Memorandum

Re: Nick Stepchinsk's Hotel Proposal: Located Between Noble Road and the I-45 Feeder Road

SITE PLAN N.T.S.

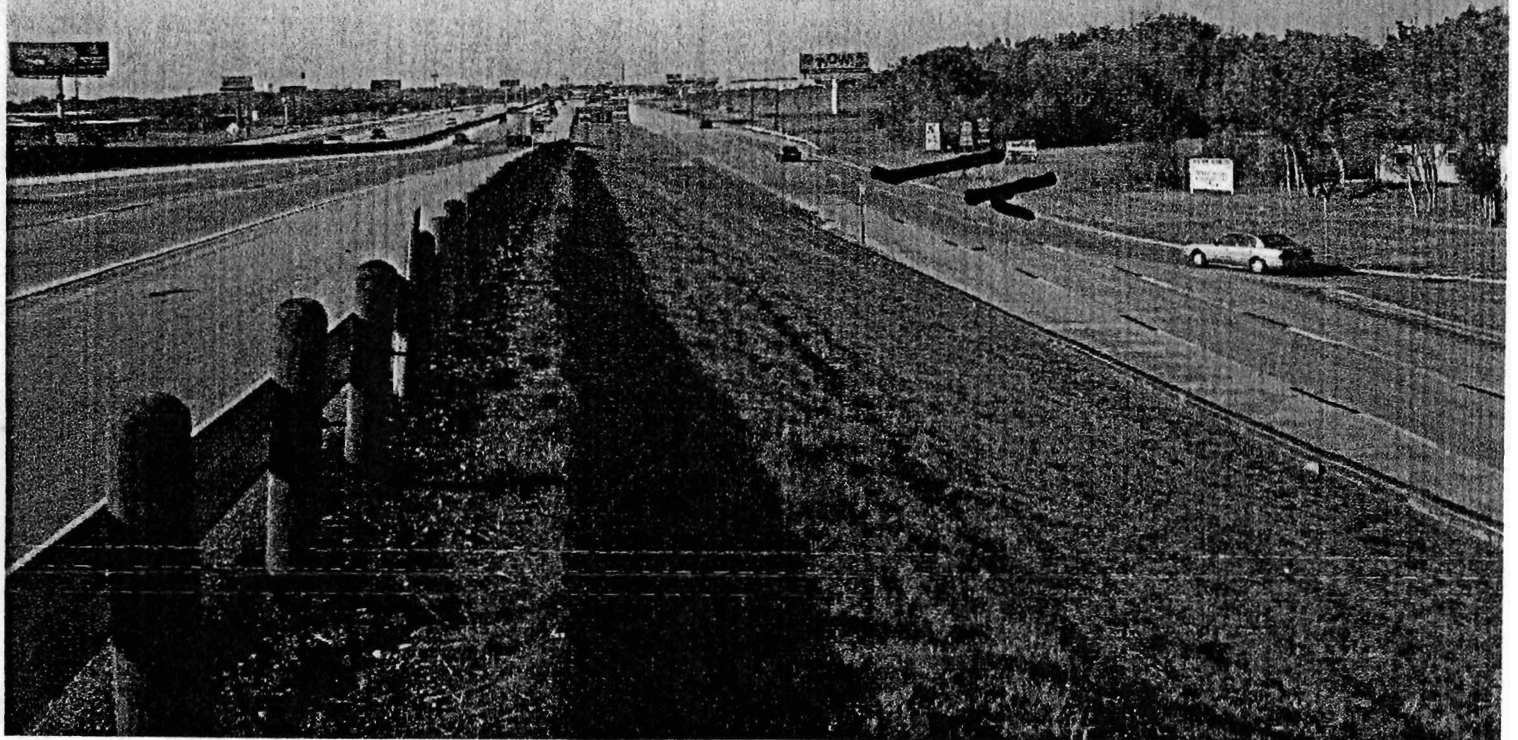
STAFF RECOMMENDED LANDSCAPED SCREENING BY 3 1/2' MASONRY FENCE

Note rd.

Where is DRIVE WAY ENTRANCE MUST SHOW AS LINED IN THE

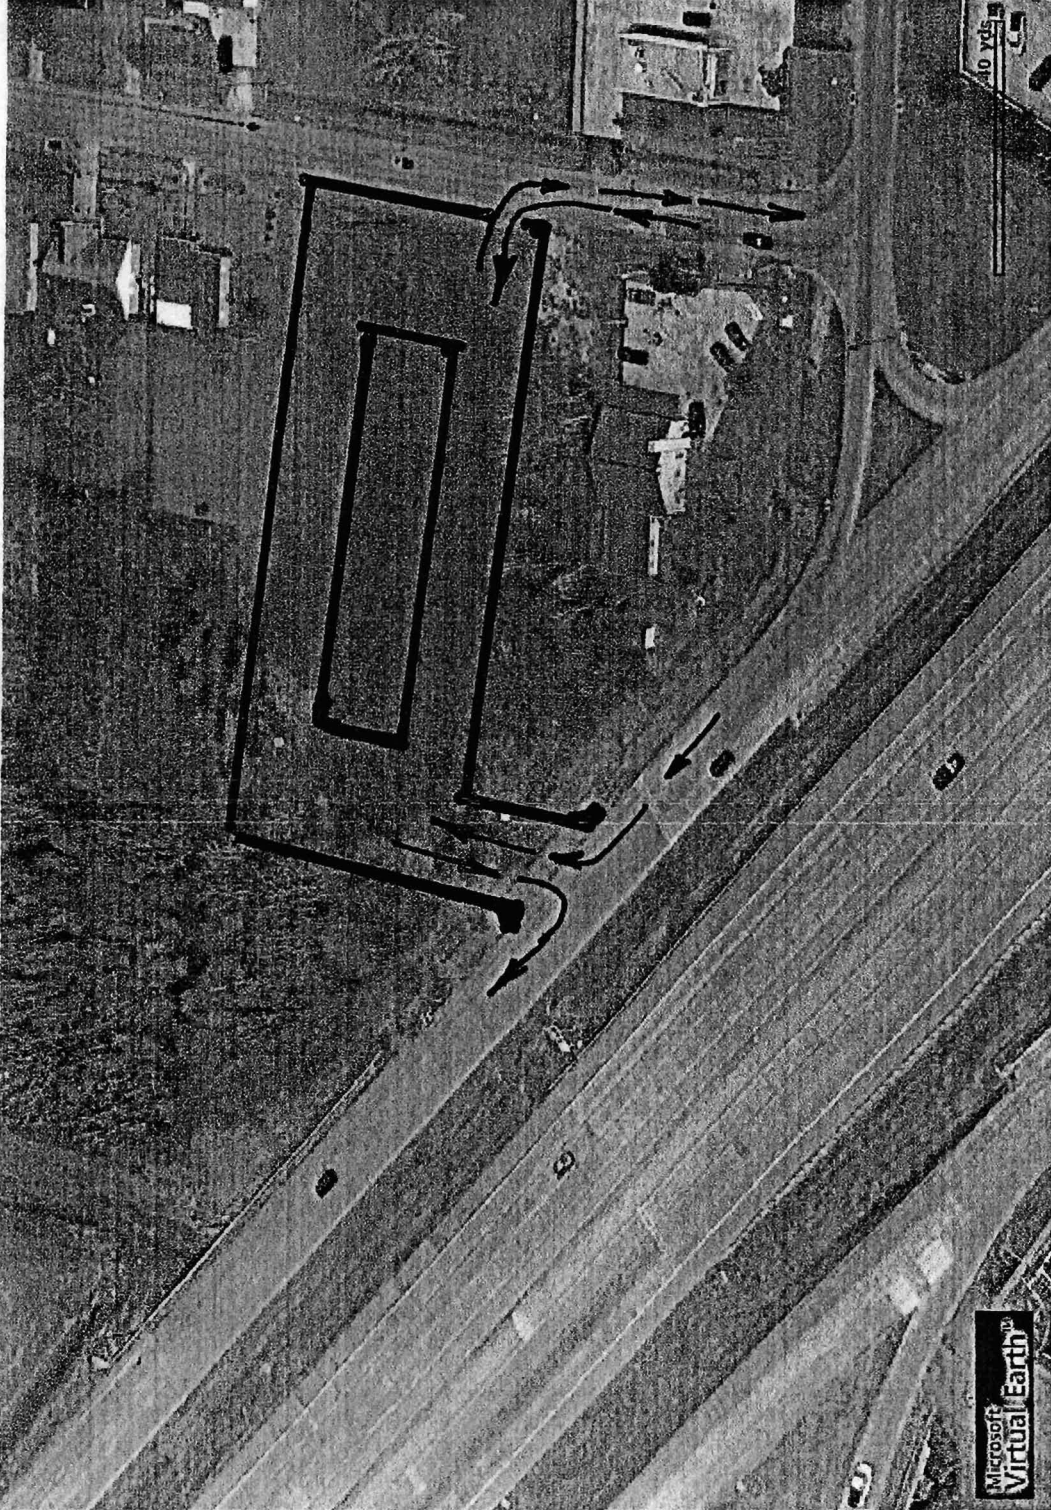
Provides @ MEETING
DRIVEWAY ENTRANCE
ALONG I-45
FEEDER
